Work Order ID 98213

Item Name: Crosstube Fwd Extended

DRAWING NO. D205-596-105	TITLE CROSSTUBE	REV. B	DART AEROSPACE LTD ENGINEERING ORDER		D.E.O. NO. D205-596-105-B-1	SHEET NO. SHEET 1 OF 1	SCALE NTS
DRAWN <i>UP</i>	CHECKED <i>PH</i>	MFG. APPR. <i>MM</i>	APPROVED <i>MD</i>		DE APPR. <i>MM</i>		
DATE 09.05.01	DATE 09.05.15	DATE 09/06/22	DATE 09/06/22		DATE 09.06.22

DRAWING NO. D205-596-105	TITLE CROSSTUBE ASS'Y, HI-HI FWD	REV. B	DART AEROSPACE LTD ENGINEERING ORDER		D.E.O. NO. D205-596-105-B-2	SHEET NO. SHEET 1 OF 1	SCALE NTS
DRAWN <i>q</i>	CHECKED <i>A.P.</i>	MFG. APPR. <i>A</i>	APPROVED <i>MP</i>	DE APPR. <i>HA</i>			
DATE 13.11.11	DATE 13.11.14	DATE 13.11.14	DATE 13/11/21	DATE 13/11/21

FIGURE 1 - SUPPORT INSTALLATION

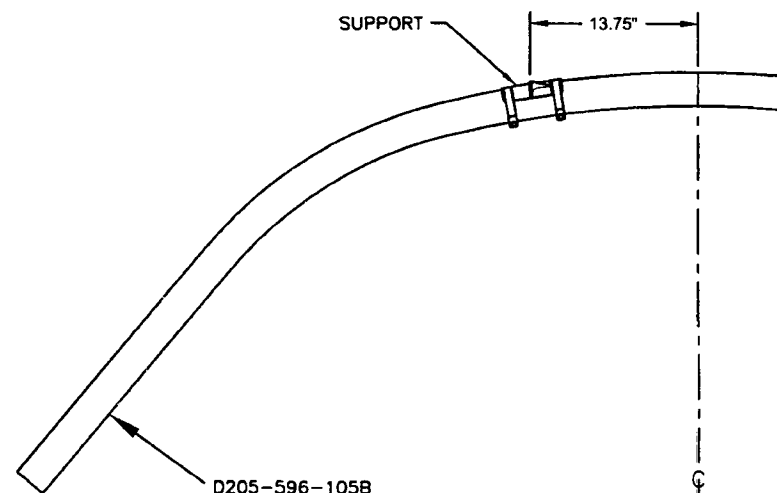
ADD THE FOLLOWING CROSSTUBE ASSEMBLY:

Part Number	Description
D205-596-105B	CROSSTUBE ASSEMBLY (214 HI-HI FWD)

THE D205-596-105B CROSSTUBE HAS THE SAME PARTS LIST AS THE D205-596-105 CROSSTUBE. HOWEVER, INSTALL THE SUPPORTS AS SHOWN IN FIGURE 1 OF THIS ENGINEERING ORDER. THE NEW KIT IS OTHERWISE ASSEMBLED PER THE D205-596-105 CROSSTUBE.

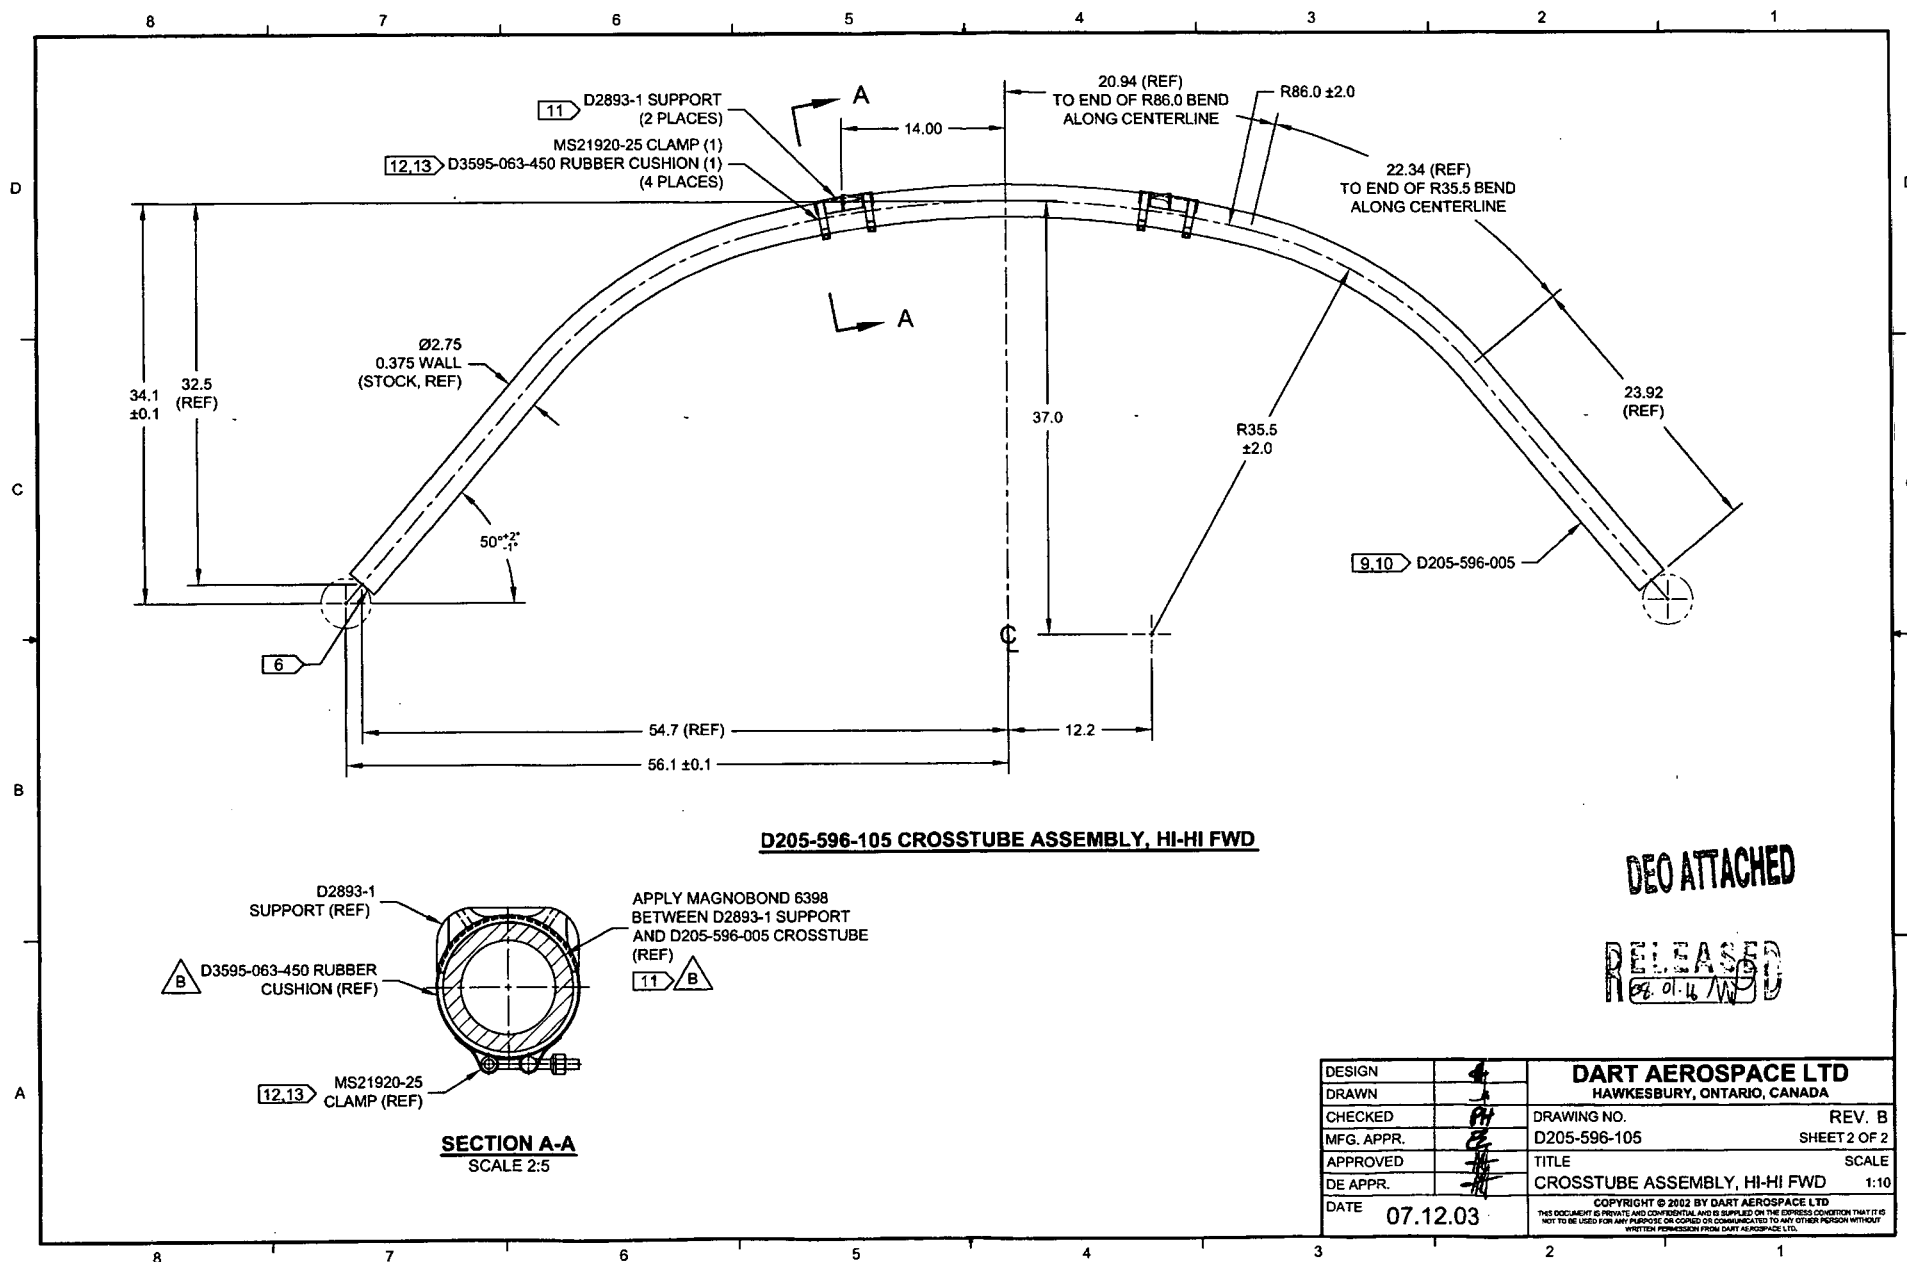
PURPOSE:

REPLACE MAGNOBOND WITH PROSEAL.

NOTE 11 & 13, SHEET 1 IS AMENDED AS FOLLOWS:

WAS:

- 11) APPLY A 0.03" TO 0.06" THICK LAYER OF MAGNOBOND 6398 TO THE SURFACE OF D2893-1 THAT WILL BE IN CONTACT WITH THE CROSSTUBE. LET CURE FOR 12 HOURS AFTER INSTALLATION AND PRIOR TO PACKAGING.
- 13) TORQUE CLAMPS 80 TO 100 IN-LB.

IS:

Qty	Part Number	Description
A/R	PROSEAL 890 B-2	SEALANT, AMS-S-8802 CLASS B-2

IS:

- 11) TO INSTALL D2893-1 SUPPORT: ABRASE MATING SURFACE OF SUPPORT AND CROSSTUBE WITH 180-GRIT SANDPAPER AND REMOVE RESIDUE WITH MEK (OR EQUIVALENT). APPLY A 0.04" TO 0.07" THICK LAYER OF PROSEAL 890 CLASS B-2 (OR AMS-S-8802 CLASS B-2) SEALANT TO MATING SURFACE OF SUPPORT.
- 13) TORQUE CLAMPS 80 TO 100 IN-LB. ENSURE AT LEAST 1.5 THREADS SHOWING IN SAFETY AND THAT NUT HAS NOT BOTTOMED-OUT AFTER TORQUING. **PRIOR TO PACKAGING, RE-CHECK TORQUE ON CLAMPS AFTER PROSEAL 890 SEALANT HAS CURED FOR 72 HOURS.**

FIGURE 1 - SUPPORT INSTALLATION

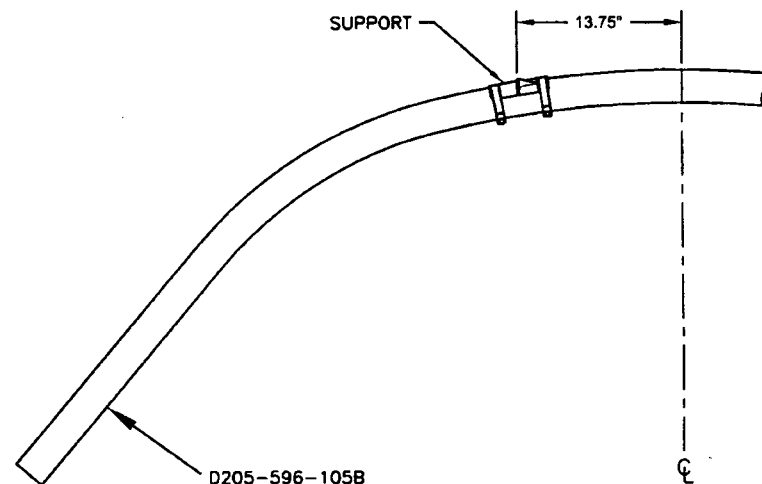
ADD THE FOLLOWING CROSSTUBE ASSEMBLY:

Part Number	Description
D205-596-105B	CROSSTUBE ASSEMBLY (214 HI-HI FWD)

THE D205-596-105B CROSSTUBE HAS THE SAME PARTS LIST AS THE D205-596-105 CROSSTUBE. HOWEVER, INSTALL THE SUPPORTS AS SHOWN IN FIGURE 1 OF THIS ENGINEERING ORDER. THE NEW KIT IS OTHERWISE ASSEMBLED PER THE D205-596-105 CROSSTUBE.
